**BRIDGE GUARDRAIL REPLACEMENT - 2015  
CITY OF ROANOKE, VIRGINIA**

**ADDENDUM No. 1 dated May 27, 2015**

**Bid No. 15-10-17**

\*\*\* APPENDIX D - REVISED PER ADDENDUM NO. 1 DATED 5/27/2015

BRIDGE 8022 - SHENANDOAH AVENUE OVER PETERS CREEK  
GUARDRAIL PLAN

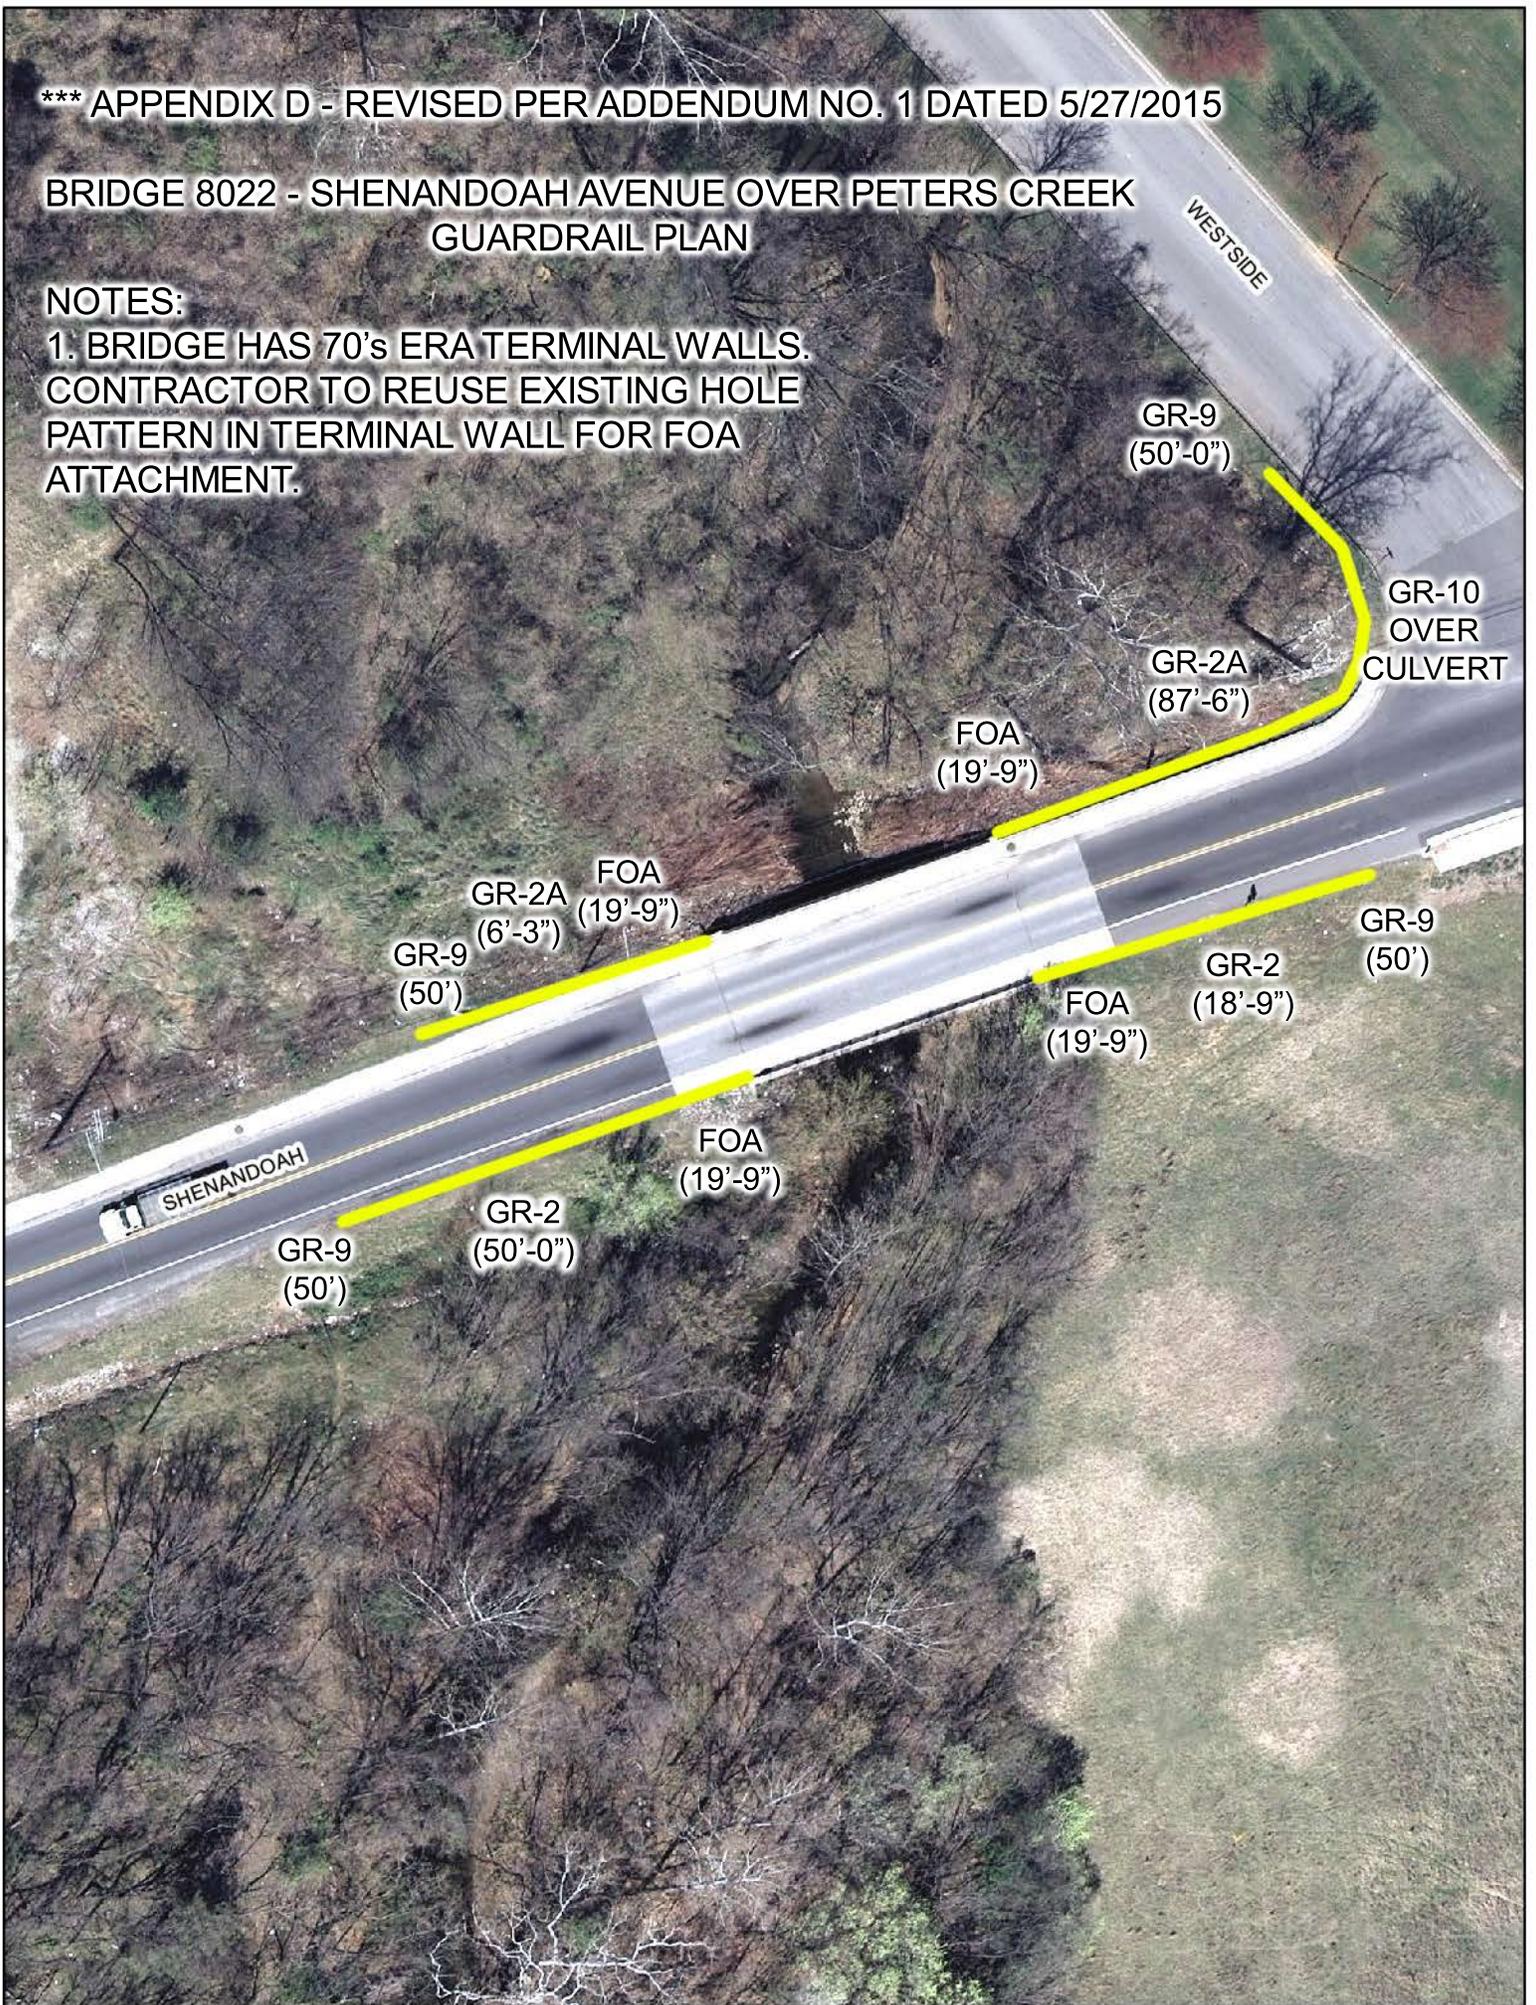
1. The guardrail exhibit for Bridge 8022 Shenandoah Avenue over Peters Creek, shown in Appendix D, has been modified. See revised Appendix D attachment. In addition, a revised bid form has been attached to reflect the modification.
2. Prior to installation of guardrail for Bridge 8022 (Shenandoah Avenue over Peters Creek), the City shall clear the vegetation on each side of the bridge to facilitate installation of guardrail.
3. Prior to the installation of guardrail for Bridge 8022 (Shenandoah Avenue over Peters Creek), the City shall pothole and determine the horizontal and vertical location of the waterline located adjacent to the bridge.
4. Bid opening date has been revised to Tuesday, June 9, 2015 at or before 2:00 p.m.

1. BRIDGE HAS 70's ERA TERMINAL WALLS.  
CONTRACTOR TO REUSE EXISTING HOLE  
PATTERN IN TERMINAL WALL FOR FOA  
ATTACHMENT.
